Informal Response to
McGuire Units 1 & 2 and Catawba Units 1 & 2
Safety Evaluation Report with Open Items

* Electrical Related Items *

09/17/2002

Enclosure 3

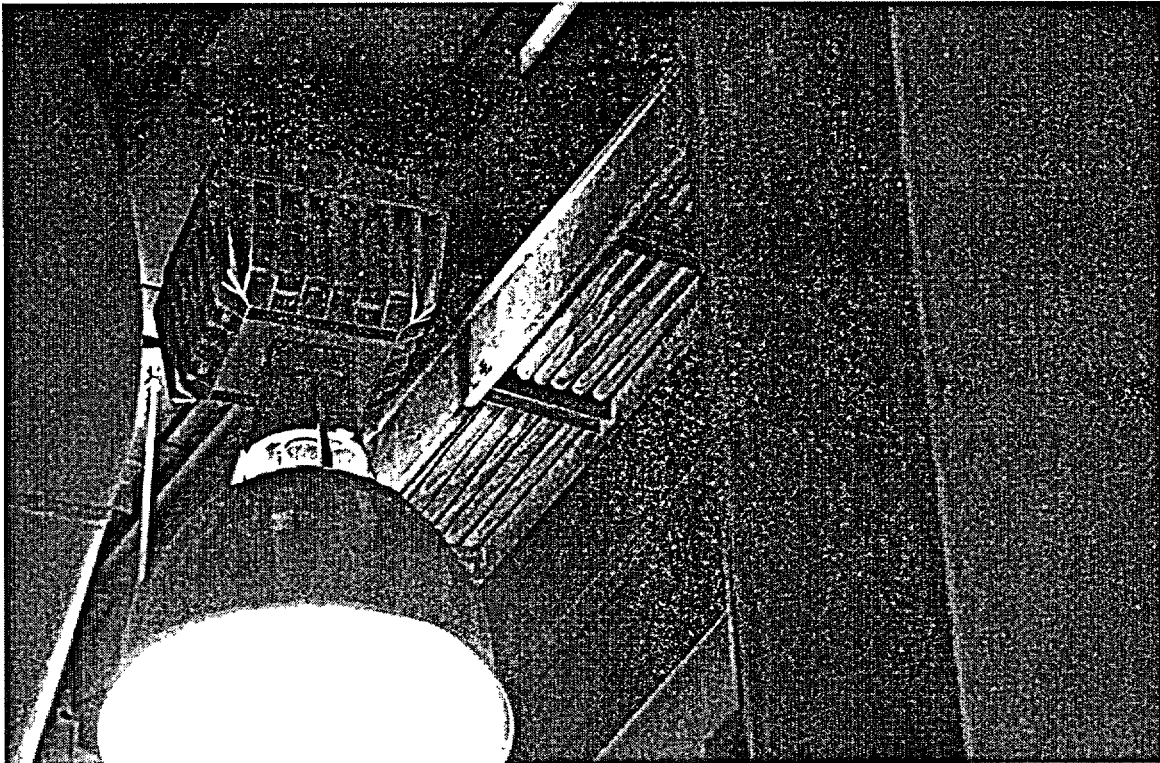
uninsulated portion of the pipe. Contact with the hot steam pipe would eventually have degraded the cables, potentially leading to a future failure. The pictured valve is installed near the ceiling in the Turbine Building, some 30 feet above the floor and would only have been found through dedicated visual inspections.

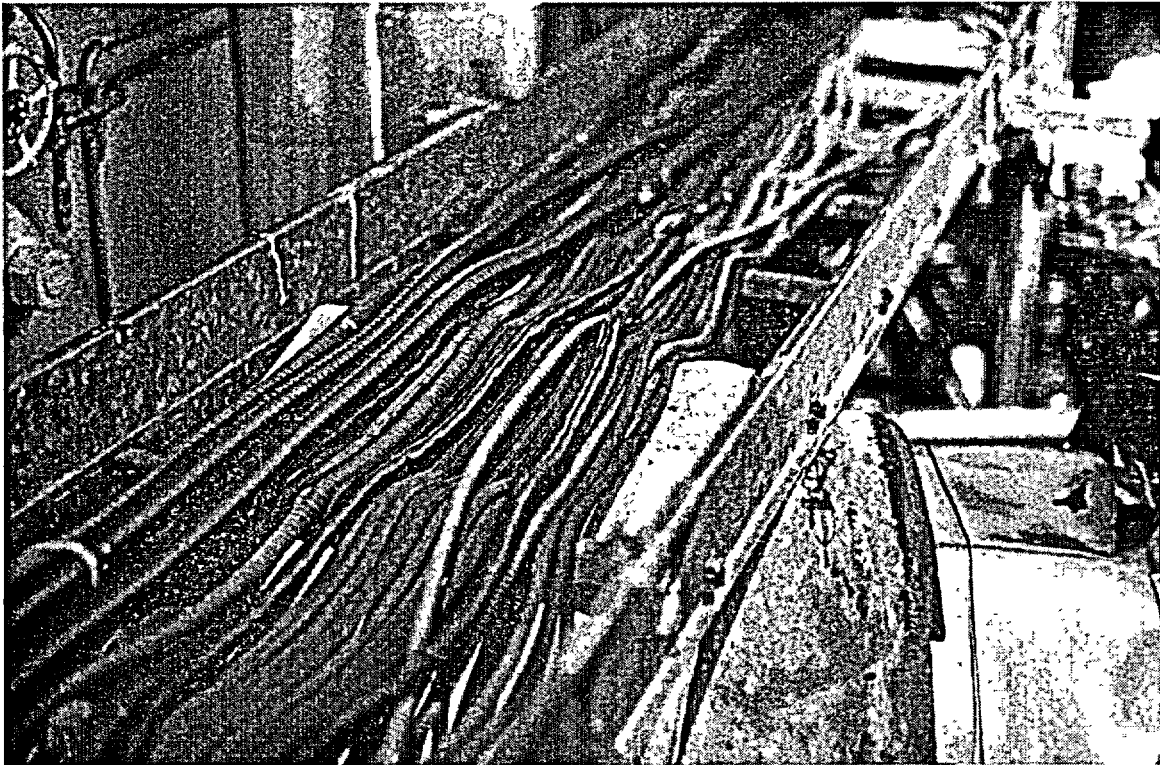
The photograph below, taken during the Oconee walkdowns, pictures instrumentation cables in a Reactor Building cable tray installed directly over a feedwater line. The heat escaping from the shield wall penetration sleeve around the pipe is accelerating the aging of the cable insulation.

The visual signs that indicate aging degradation of cables in the tray are the way the cables “droop” between the cable tray lattice supports and many of the cable jackets look “dry” and have surface cracks.
